State of New Mexico
Energy, Minerals and Natural Resources

Form C-103
Revised July 18, 2013

2. Name of Operator ConocoPhillips Company		6. State Oil & Gas Lease No. B-2423-12
3. Address of Operator 925 N. Eldridge Pkwy Houston, TX 77079		7. Lease Name or Unit Agreement Name East Vacuum GB-SA Unit Tr 2962

**CONDITIONS OF APPROVAL
FOR PLUGGING AND ABANDONMENT
OCD - Southern District**

WELLBORE SKETCH
ConocoPhillips Company - Permian Basin Business Unit

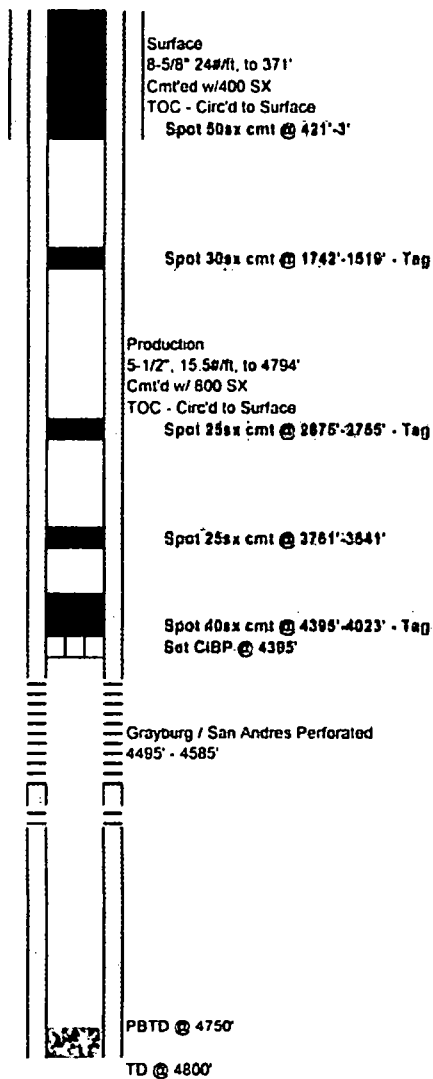
--MIRU. ND WH, NU BOP. POOH Prod Equipment
--Set CIBP @ 4395' - Circ hole w/ MLF. Pressure test casing. Spot 40sx cmt @ 4395' - 4023'. WOC-Tag
--Spot 25sx cmt @ 3761' - 3641'
--Spot 25sx cmt @ 2875' - 2755'. WOC-Tag
--Spot 30sx cmt @ 1742' - 1519'. WOC-Tag
--Spot 50sx cmt @ 421' - 3'
--POOH. Fill wellbore. Verify cmt @ surface in all annuli
--Cut off WH & anchors. Install DH marker

APPROVED BY: Kenny Jute TITLE C O A DATE 5-21-20
Conditions of Approval (if any):

17. A CIBP is to be set within 100' of production perforations, capped with 100' of cement, WOC 4 hours and tag.
18. A CIBP with 35' of cement may be used in lieu of the 100' plug if set with a bailer. This plug will be placed within 100' of the top perforation, (WOC 4 hrs and tag).
